CITY OF JOPLIN
ADDENDUM NUMBER 1

Project Name: Joplin Streets Mill and Overlay 2023

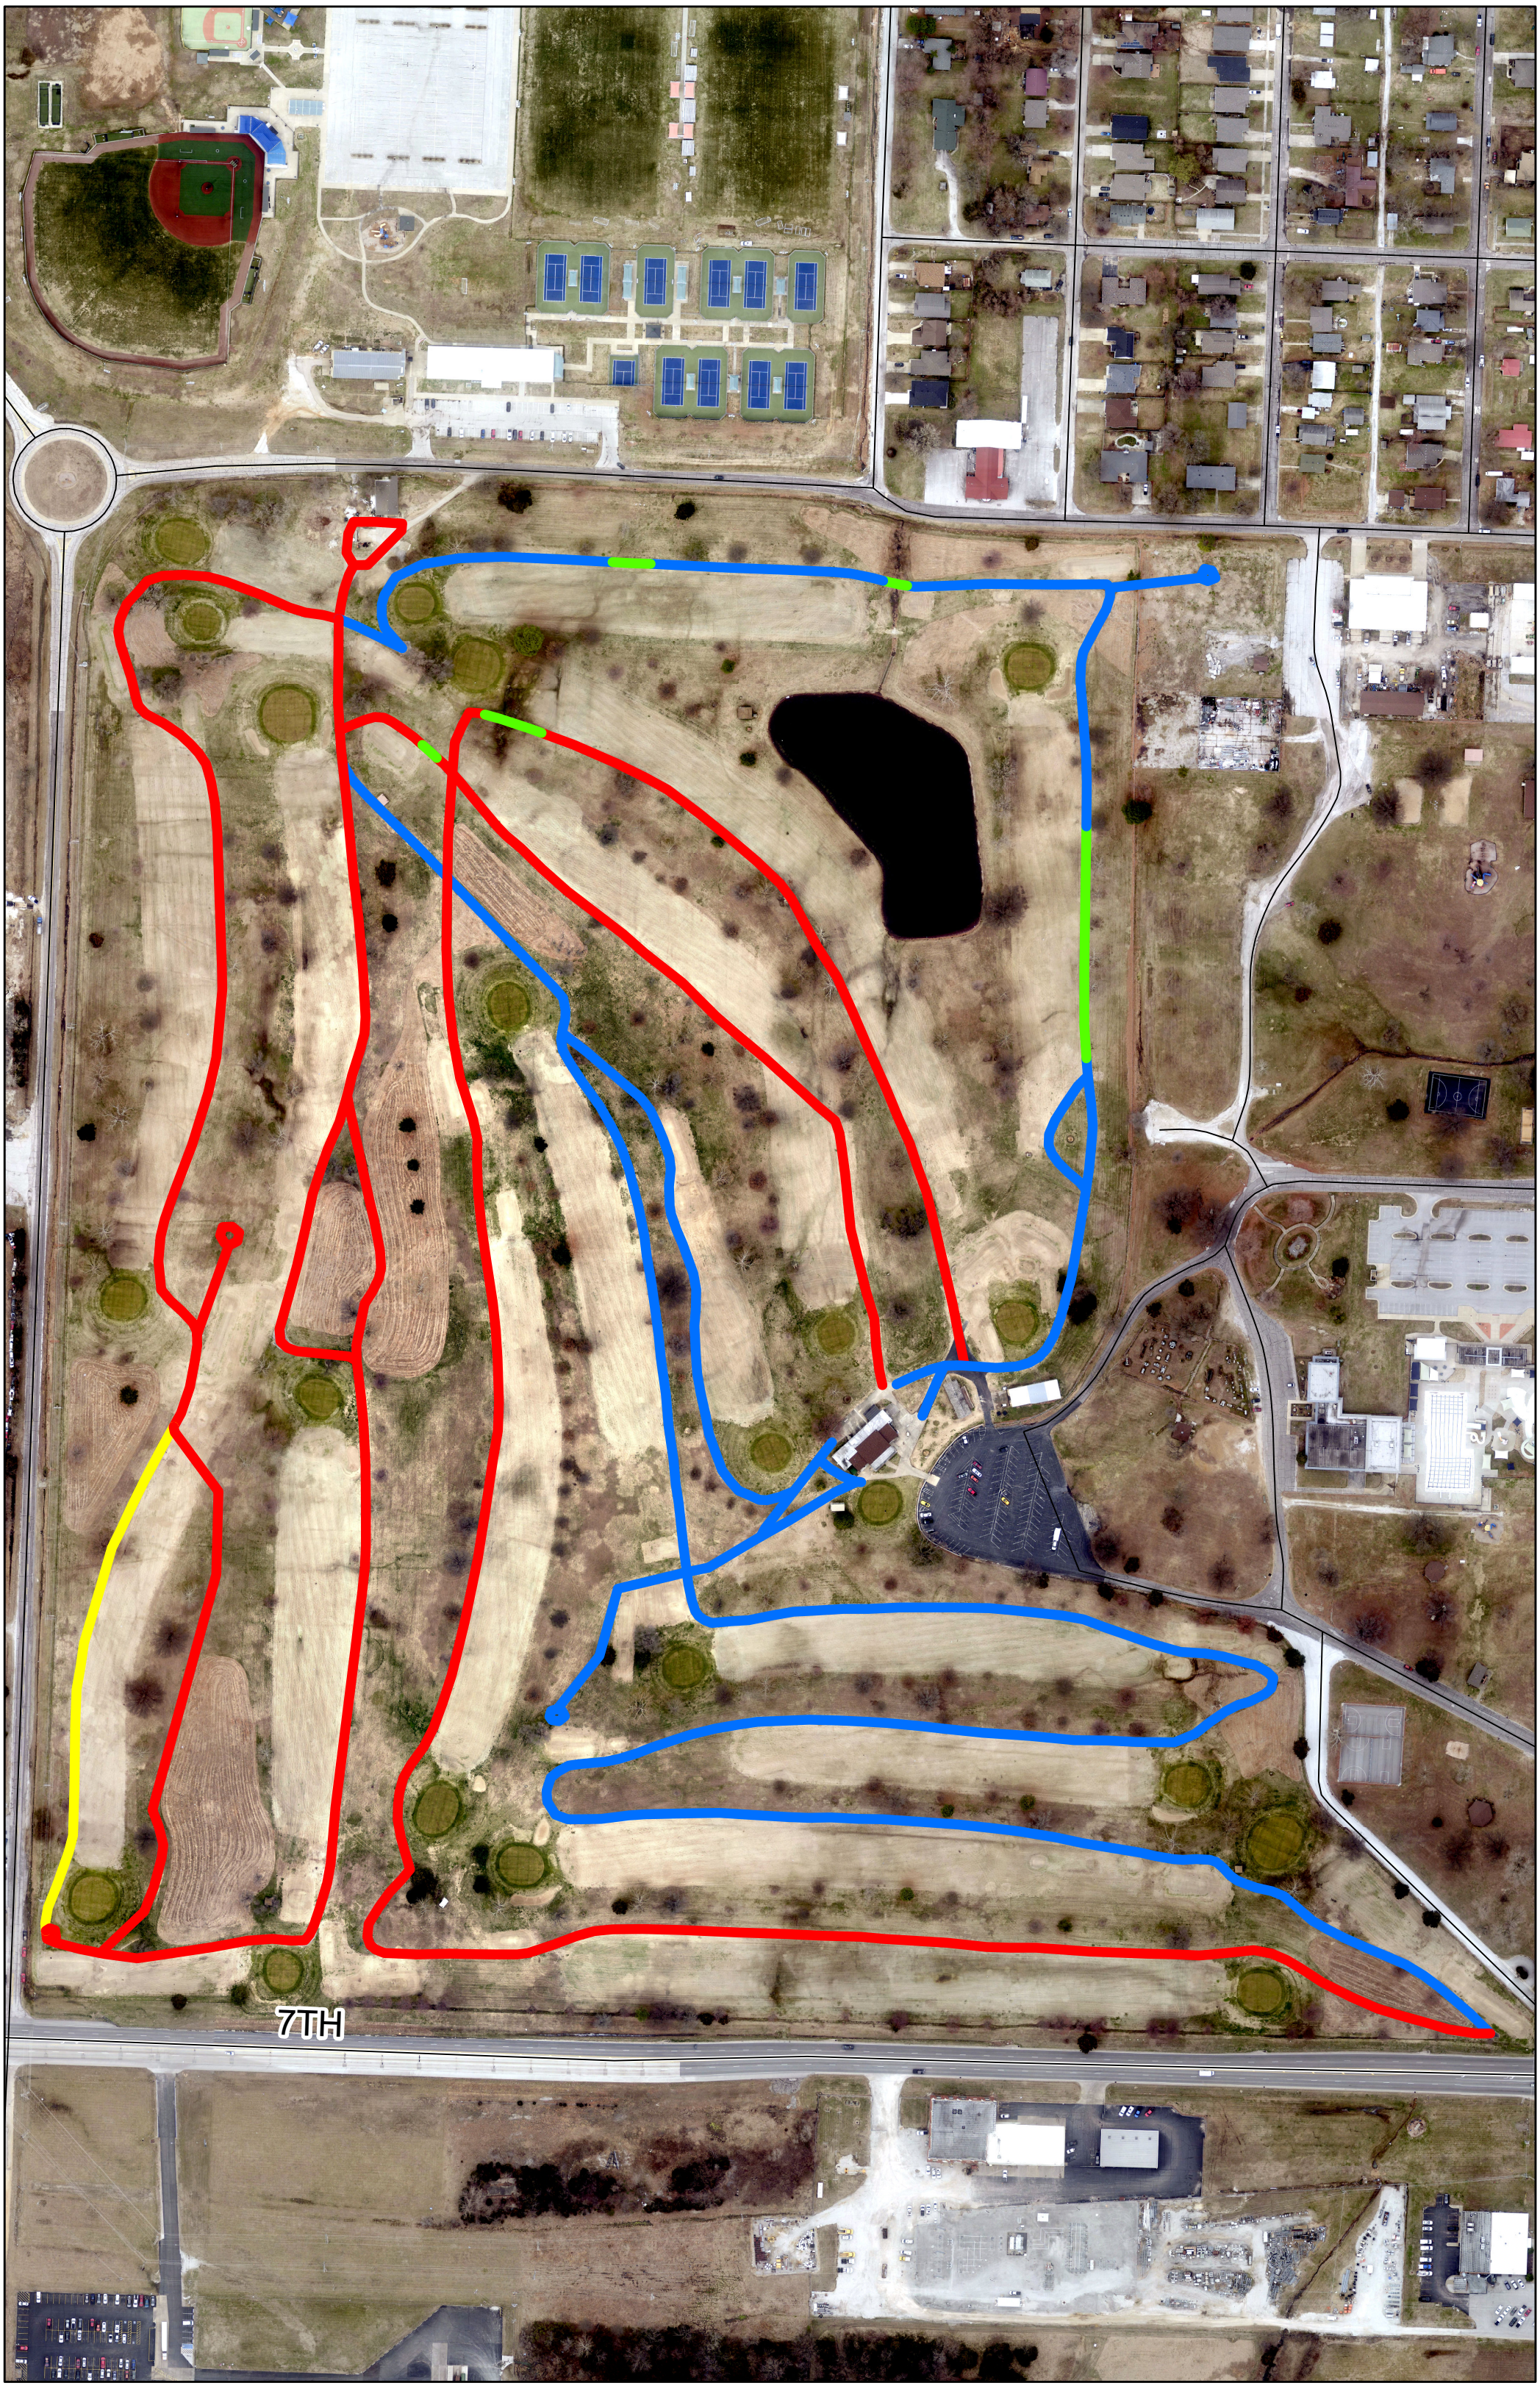
6) **Maps are included for the streets to be paved with the crosswalk locations marked by blue squares. The golf course paths map is also attached. Red indicates Phase 1, Blue indicates Phase 2, Green represents concrete path that is not to be paved over, and Yellow is an existing path that will be rerouted and is not to be paved.**
